2. Name of Operator				Frisbee BIF Federal Com #1	
Yates Petroleum Corporation				9. API Well No.	
3a. Address 3b. Phone No. (include area code)				30-005-6381	0
105 S. 4th Str., Artesia, NM 88210 575-748-1471				10. Field and Pool	or Exploratory Area

4. Location of Well (Footage, Sec., T., R., M., OR Survey Description)				Greenfield;Wolfcamp, South	
Surface - 660'FSL & 660'FEL of Section 33-T13S-R27E (Unit P, SESE)				11. County or Parish, State	
BHL - 660'FNL & 778'FEL of Section 33-T13S-R27E (Unit A, NENE)				Chaves County, New Mexico

Order No. 04-029-11W

NOTICE OF ORDERS OF THE BLM AUTHORIZED OFFICER CTION DEPARTMENT RECEIVED

WEUHEAD-PUMPJACK

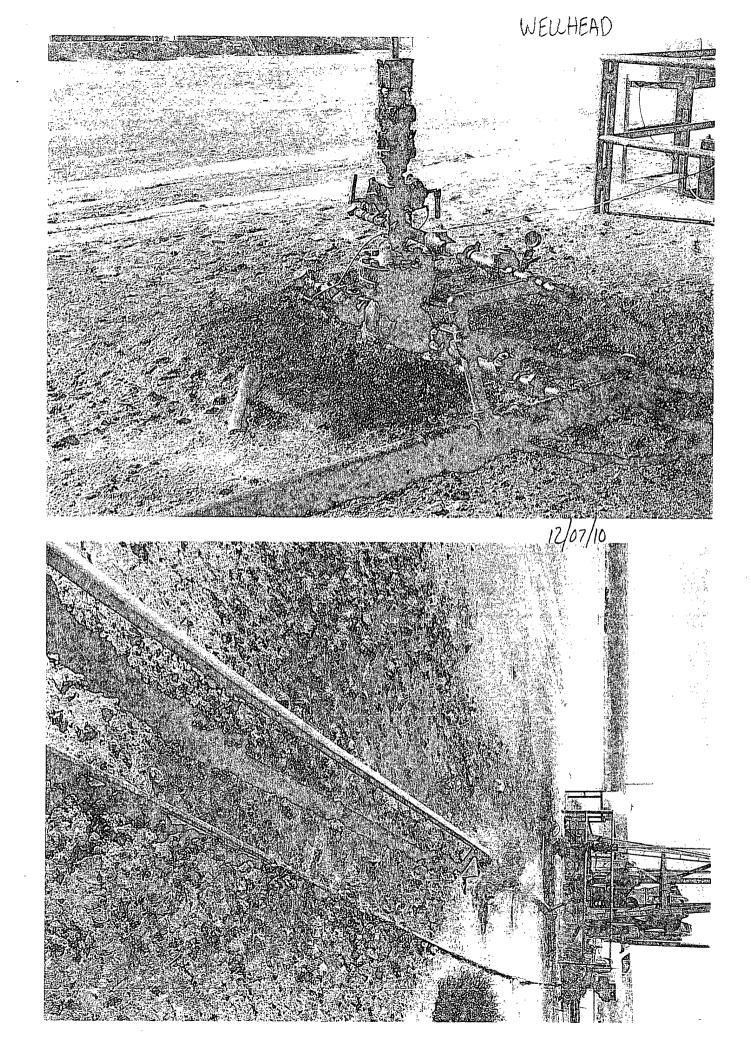
• Environmental Problem No. 1: WELL CASING IS LEAKING PRODUCED WATER

Corrective Action: The well casing needs to be repaired and all stained soil on the location shall be excavated and disposed of at an authorized disposal facility. Excavated areas shall be backfilled with clean earthen material and re-contoured to mirror the contours of the surrounding terrain.
